PEER REVIEW REPORT

Lower East Coast subRegional Groundwater Flow Model and Draft Model Documentation

South Florida Water Management District

June 7, 2006

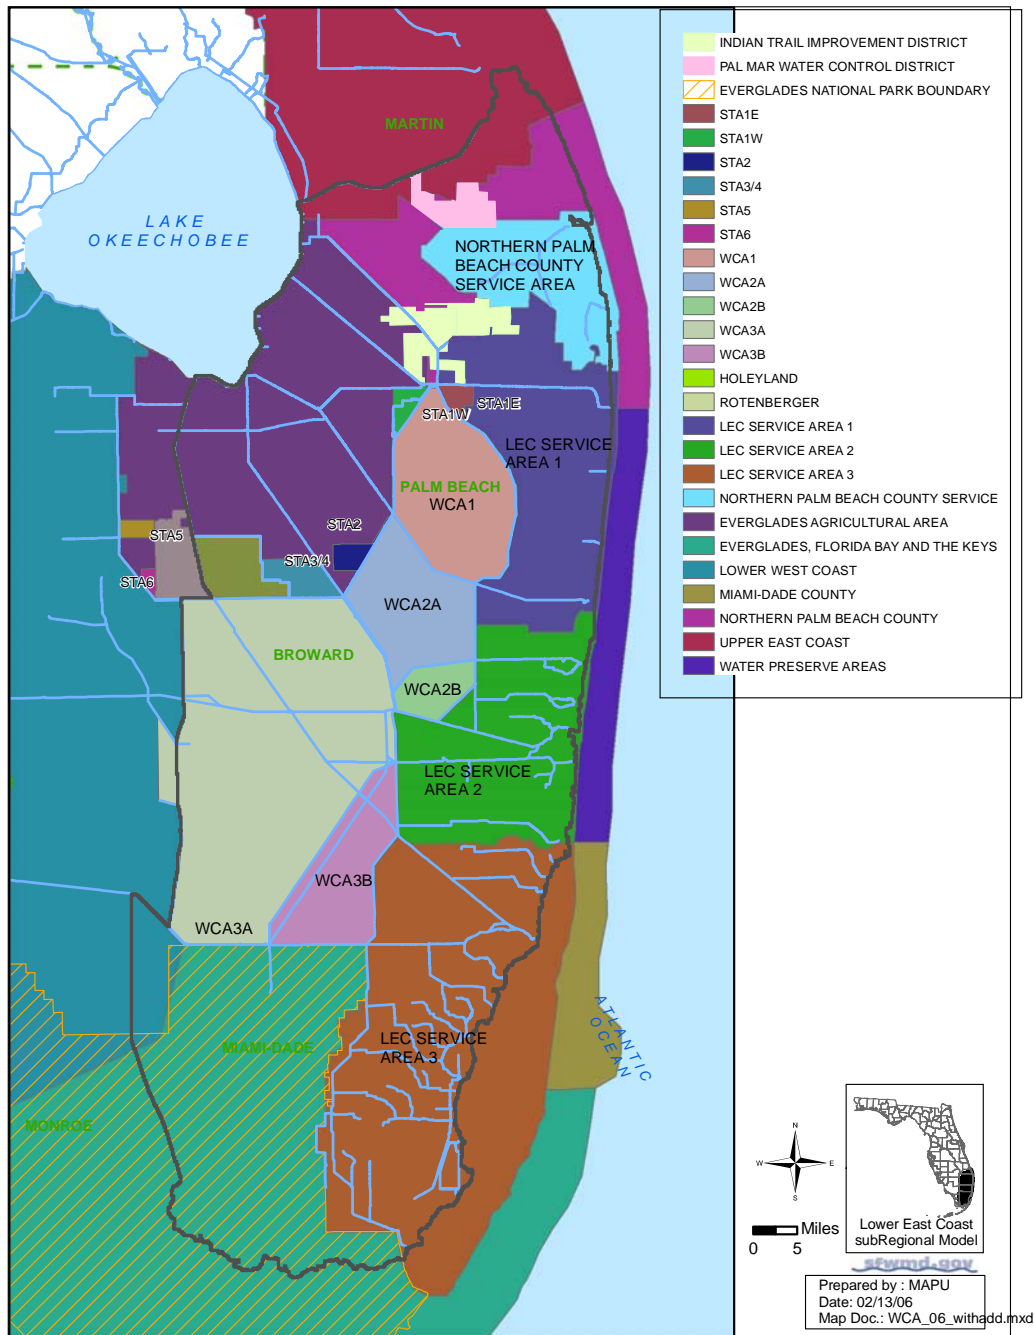
Comment / Question 17: What are the unclassified areas (white) east and southeast of Lake Okeechobee that are included in the model but not given any designation in the figure?

Response 17: This figure has been revised according to the above suggestion. The white areas were labeled.

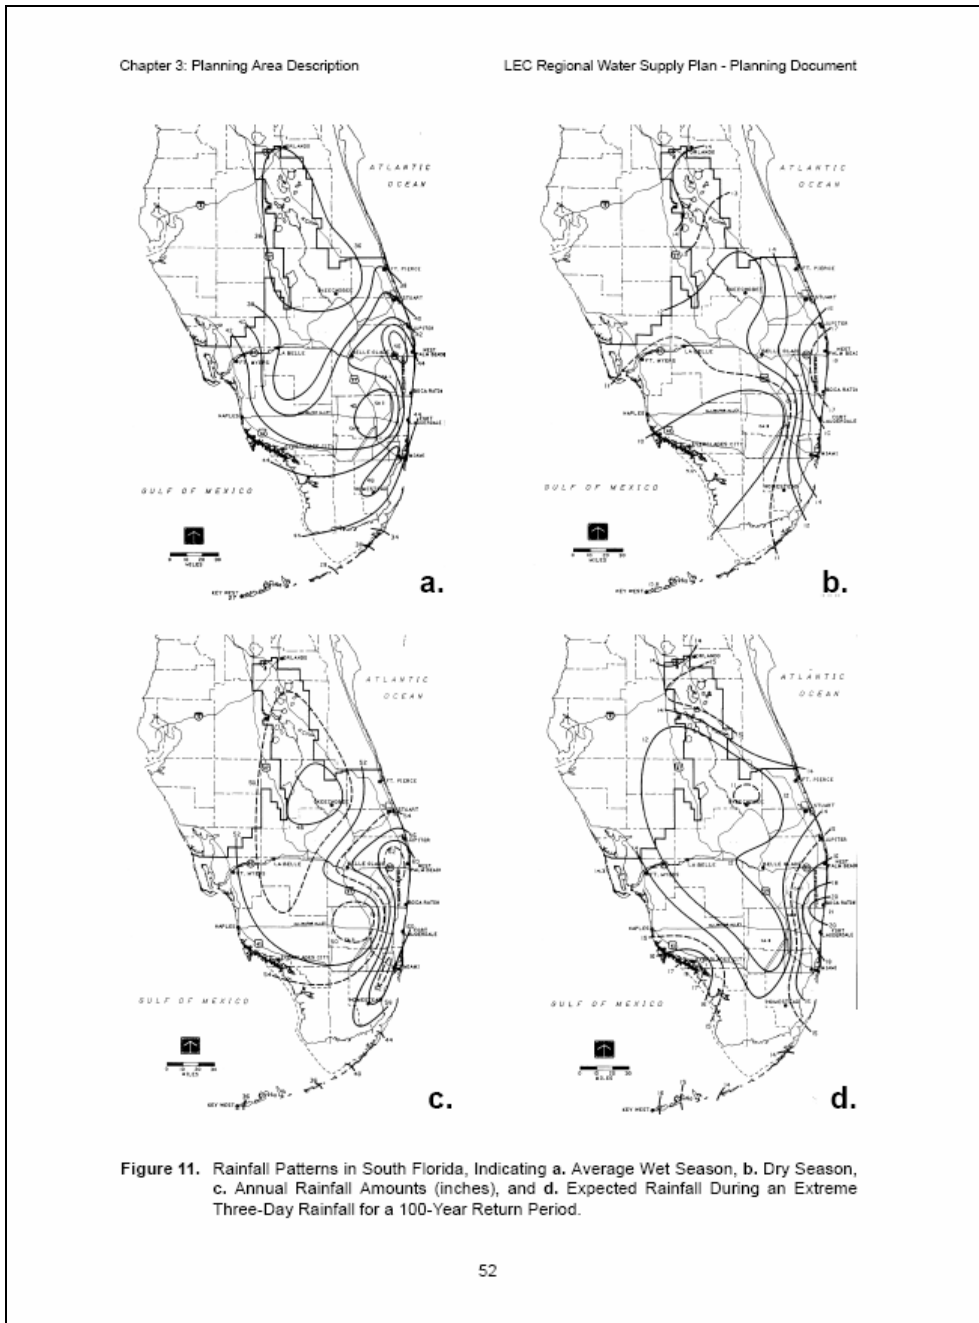
Comment / Question 20: Can a map be provided that shows more detail of the average annual spatial distribution of precipitation rather than simply stating that precipitation is typically higher along the coast?

Response 20: A figure from the Lower East Coast Water Supply Plan (SFWMD 2000) shows the rainfall patterns.

Figure 1. Water Use by Class in 2004.

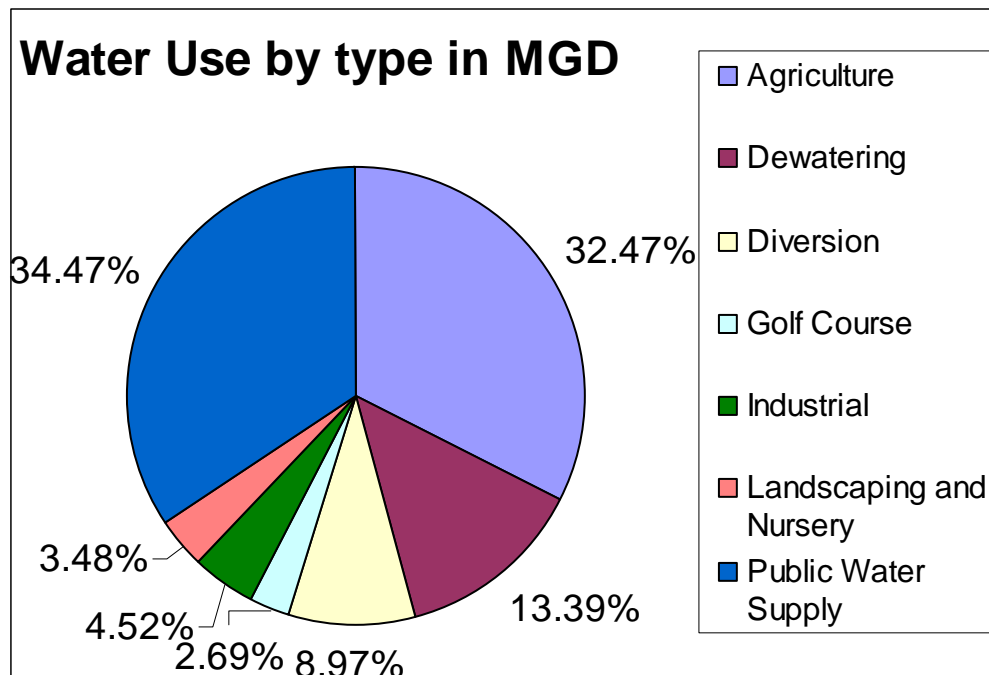
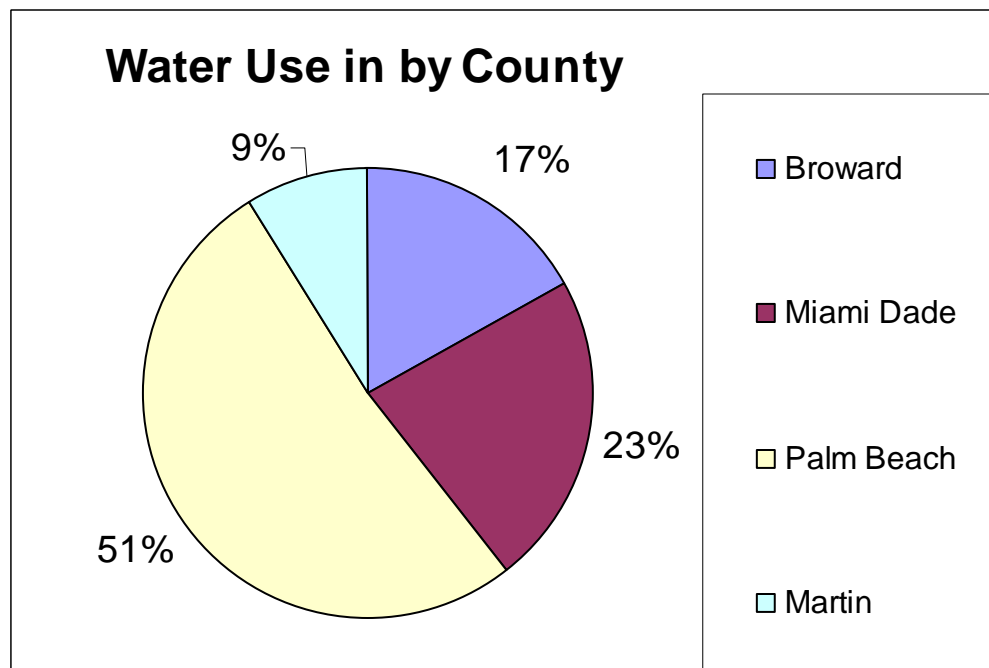
Comment / Question 29: Figures 36 and 37 are inconsistent with Table 4. For example, Table 4 lists ag as 1034 mgd, which is about 32% of total use, whereas Figure 36 shows it at 4%, Public water supply is 1097 mgd, which is 34%, while Figure 36 shows it at 53%. Similarly, Table 4 shows Broward County at 539 mgd or 17%, but Figure 37 shows it at 2%. Which is correct? Is there any real doubt about these numbers?

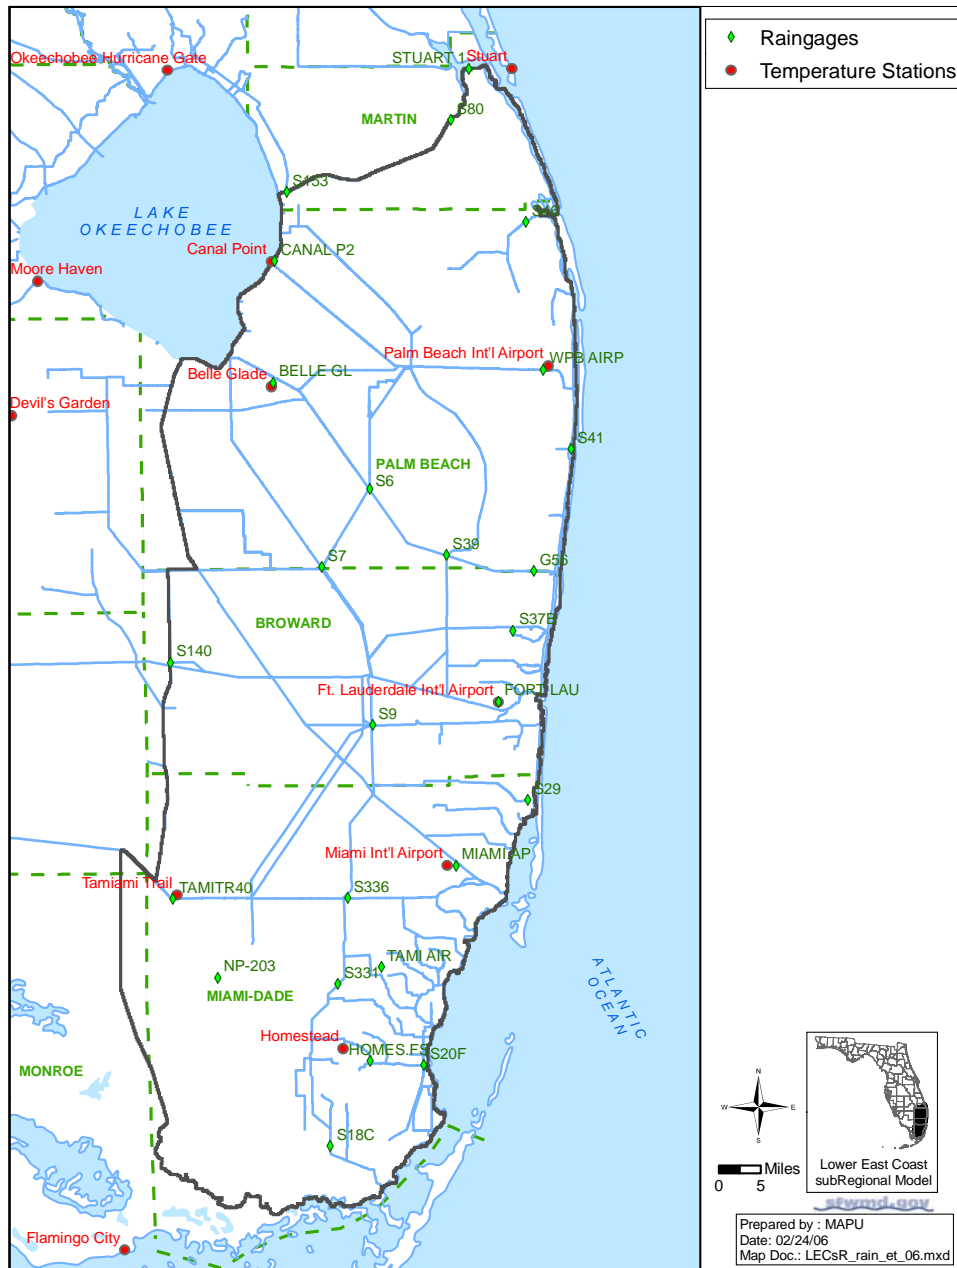
Comment / Question 33: Caption refers to Rainfall and Temp stations, legend calls out Rain and ET stations.

Response 33: The figure was corrected to reflect that temperature values were used to generate ET. Temperature data was the only climatological variable needed for the Simple Method.

Figure: Average Annual Rainfall (in) from 1965 -2000 by Month.

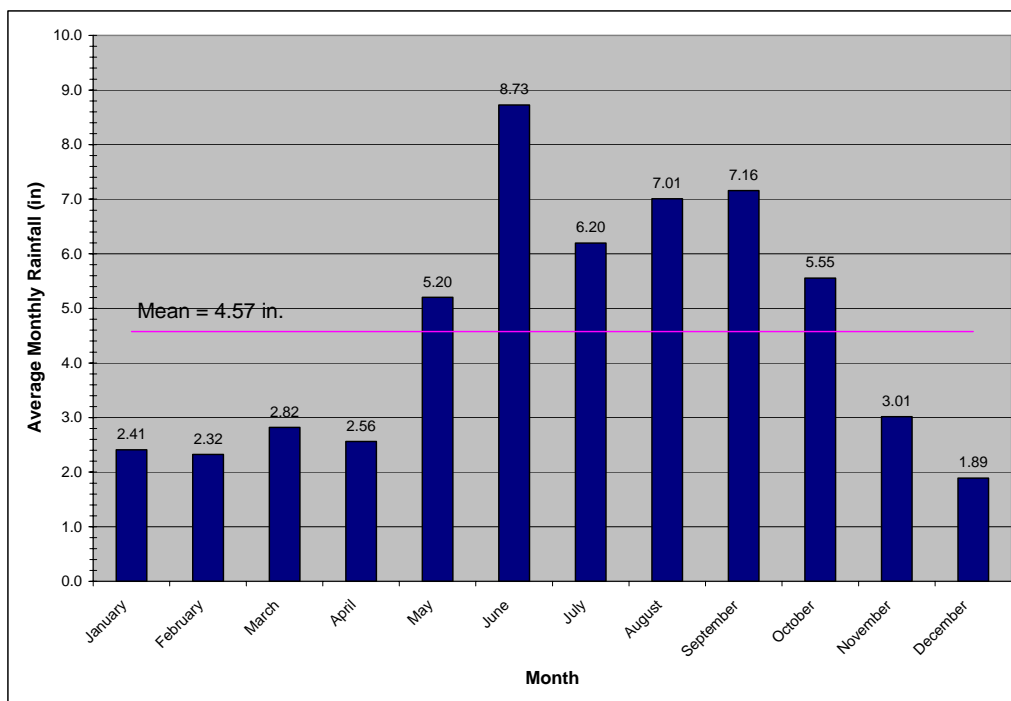
Comment / Question 35: The "Mean = 5 in." line is drawn on the graph at about 4.6".

Response 35: The figure has been corrected.

Figure : Average Annual Rainfall (in) from 1965 -2000.

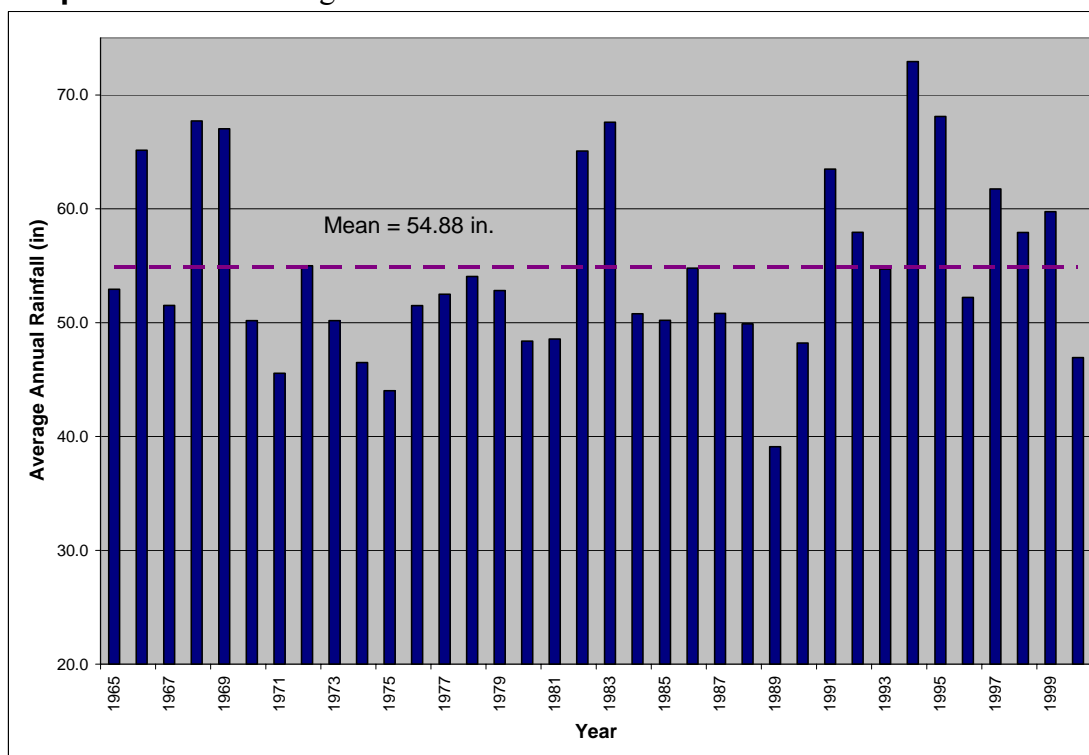
Comment / Question 36: The "Mean = 57 in." line is drawn on the graph at about 56.5".

Response 36: The figure has been corrected.

Figure: Average Annual Evapotranspiration (in) for Wet Marsh from 1965 -2000.

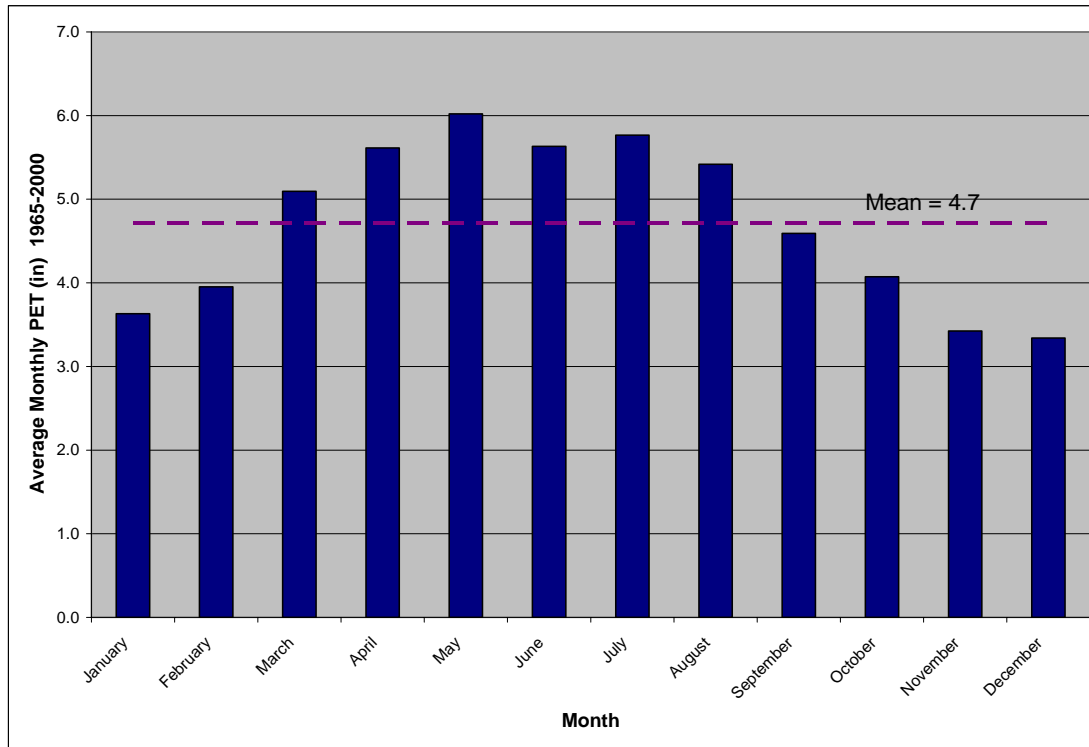
Comment / Question 37: The "Mean = 5 in." line is drawn on the graph at about 4.75".

Response 37: The figure has been corrected.

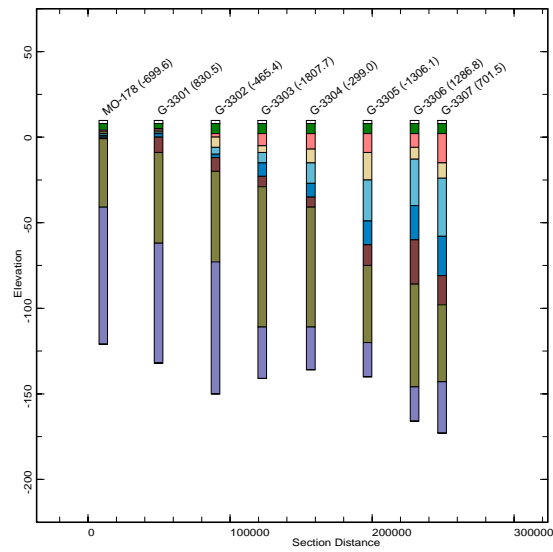
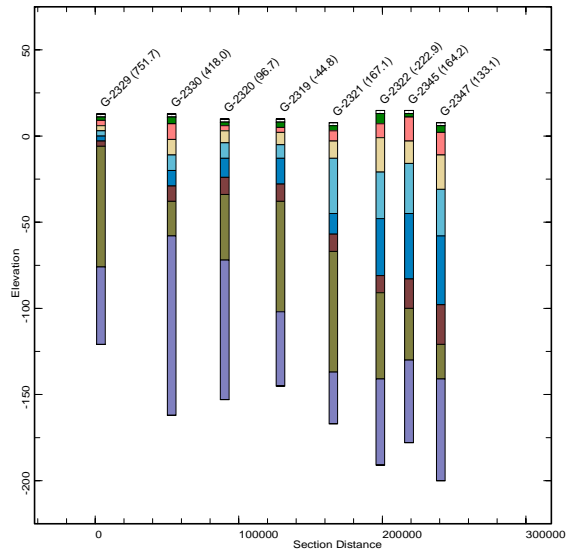
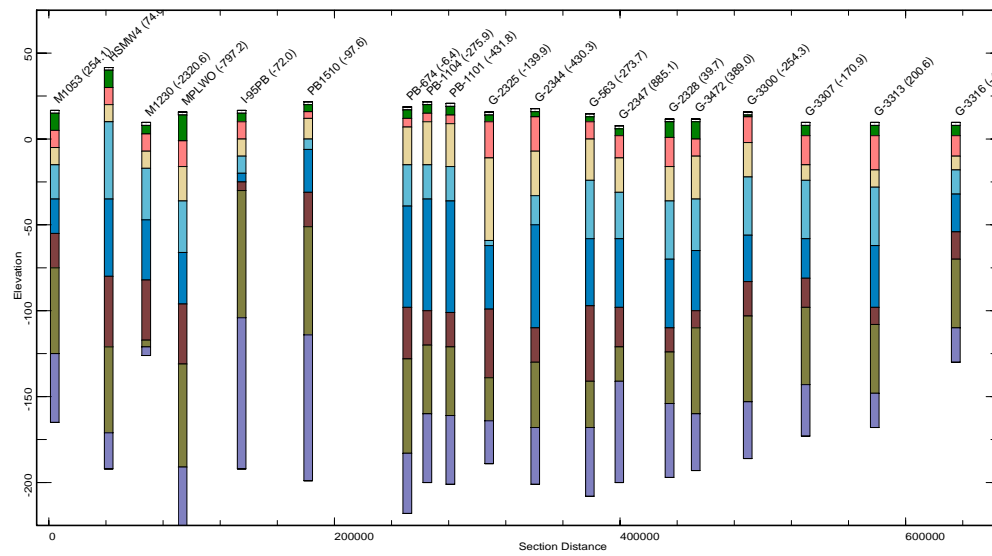
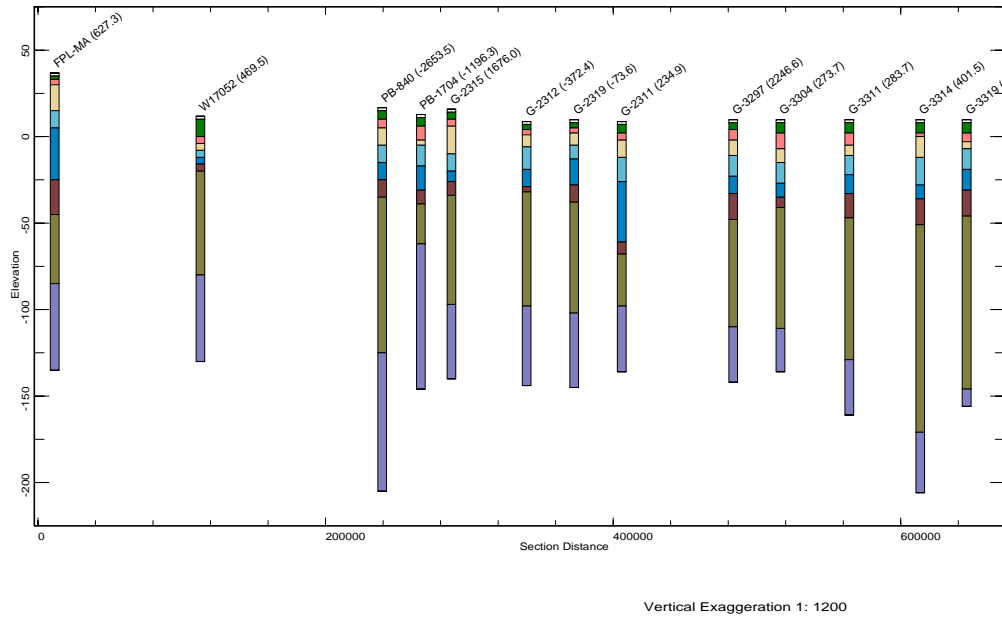
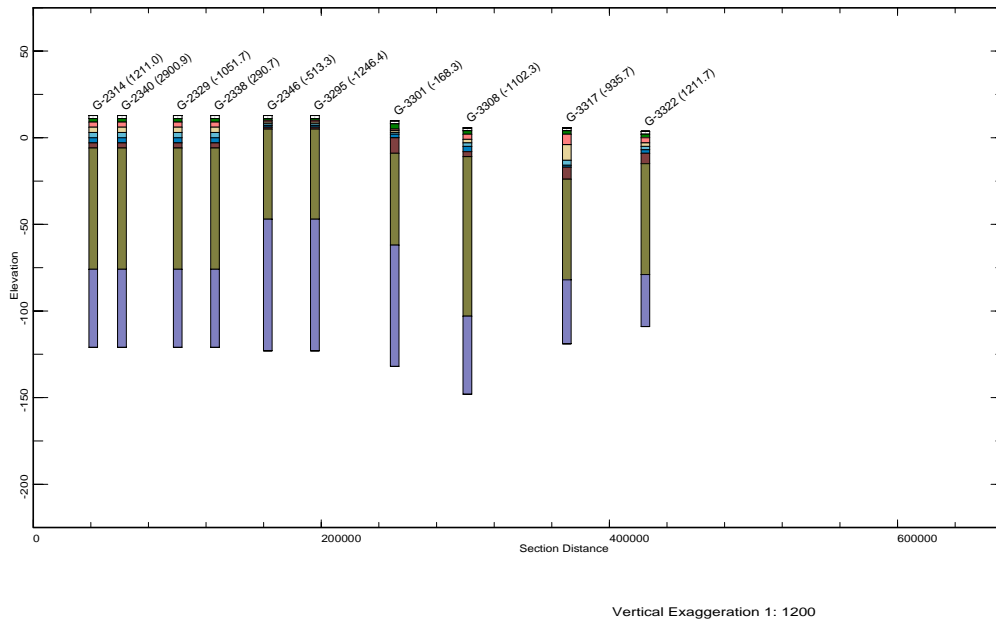
Comment / Question 45: There is no common vertical scale to facilitate comparison of the cross-sections. For example, Figure 19 vertical scale is +90' to -182' while Figure 20 vertical scale is +105' to -300'.

Response 45: New figures have been created by applying a common vertical scale and will be added to the documentation.

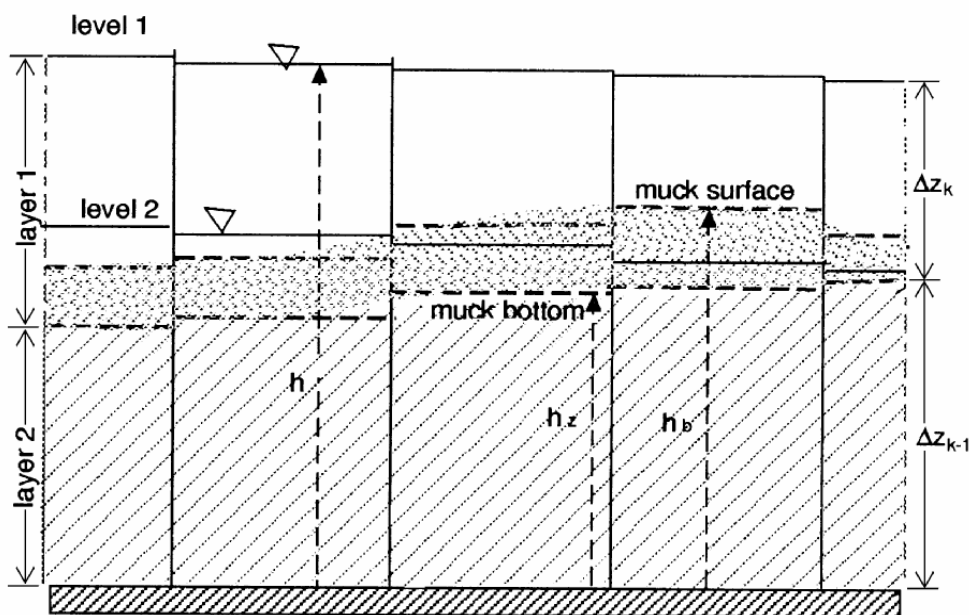
Comment / Question 54: Are all layer one cells enabled in the Wetland Package? There are variables in Figure 43 that are not explained in the text (e.g., h_z , h_b , z_k , etc.). How was the WTL Package validated? How sensitive is it to the selection of a and b ? Are a and b calibration parameters? What do α and β refer to? How were they selected? How are they distributed?

Response 54: This section, Add-on Packages describes the computer code. The model design for the Wetland Package is discussed in the second part of Chapter 3 and shown in Figure 62. No, not all of the cells in layer one are enabled in the Wetland Package, but they could be. The Wetland Package defines the active model cells that will be simulated as wetlands (`ibnd_wtl`) just as the active groundwater cells are defined in the Basic Package. The user must select the areas considered as wetlands.

H is the water table elevation in layer one (level 1) when there is ponded water in all wetland cells. The level 2 water table elevation illustrates a drier hydropattern when the water table falls below land surface in some of the wetland cells, but remains ponded in other wetland cells. H_z is the bottom elevation of layer one. H_b is the top elevation of the muck or peat. ΔZ_k is the saturated thickness of layer one, including the ponded water. ΔZ_{k-1} is the thickness of layer 2 – layer underlying the wetlands.
